INDIANA DEPARTMENT OF TRANSPORTATION

Design Memorandum No. 19-10

SUBJECT: Terminal Joints

REVISES: *Indiana Design Manual (IDM) Sections 17-5.09(01), 402-7.02(03) and 409-2.04*

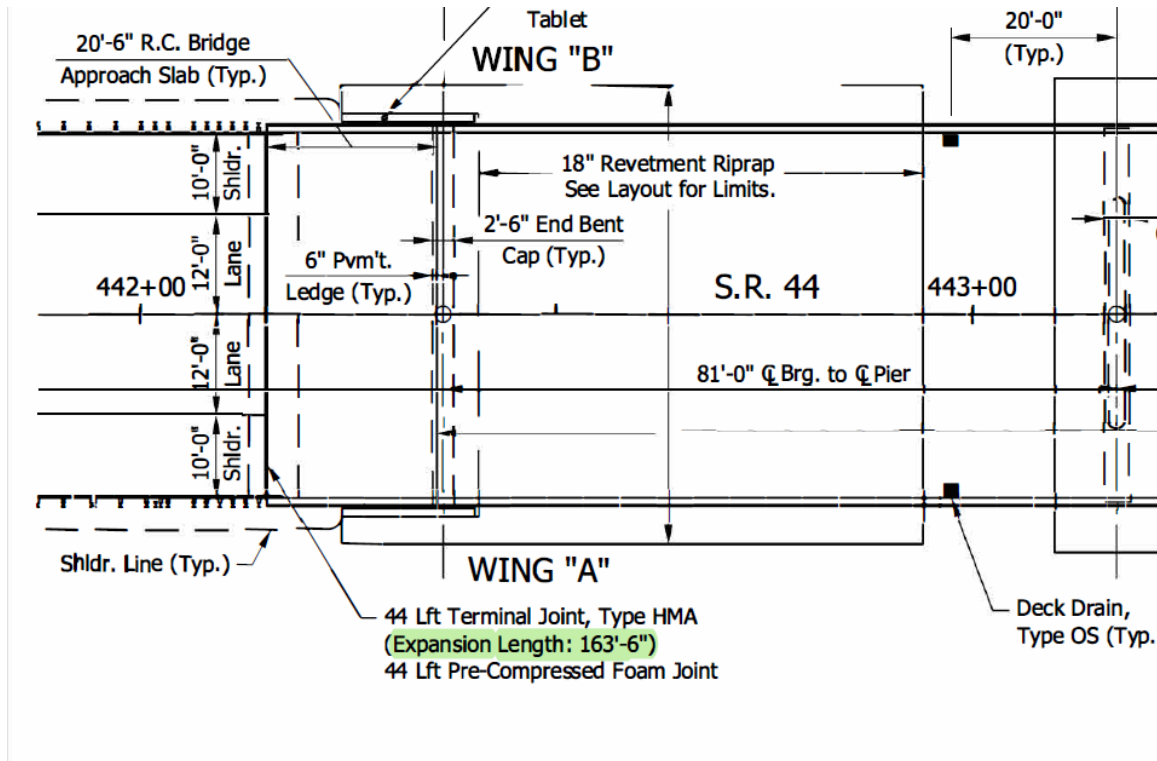
- Pre-compressed foam joint (RSP 724-B-309) replaces 2-ft wide HMA section.
- Consistent subbase and subgrade treatment under RCBA, sleeper slab, and approach pavement.
- Separate details for HMA approach pavement and PCCP approach pavement.
 - HMA approach details use a concrete lug.
 - PCCP approach details use a series of jointed reinforced concrete pavement sections.

A terminal joint is required where there is PCCP pavement on the approach.

A terminal joint is required where there is HMA pavement on the approach when the following exist

- The bridge has an integral or semi-integral end bent, and
- The bridge expansion > 1/4 in. but not greater than 4 in. 1/4 in. expansion approximately equates to an expansion length equal to 100 ft for concrete and 50 ft for steel.
 - Expansion < 1/4 in. does not require a terminal joint
 - Expansion > 4 in. cannot be accommodated by the terminal joint. A special detail is required.
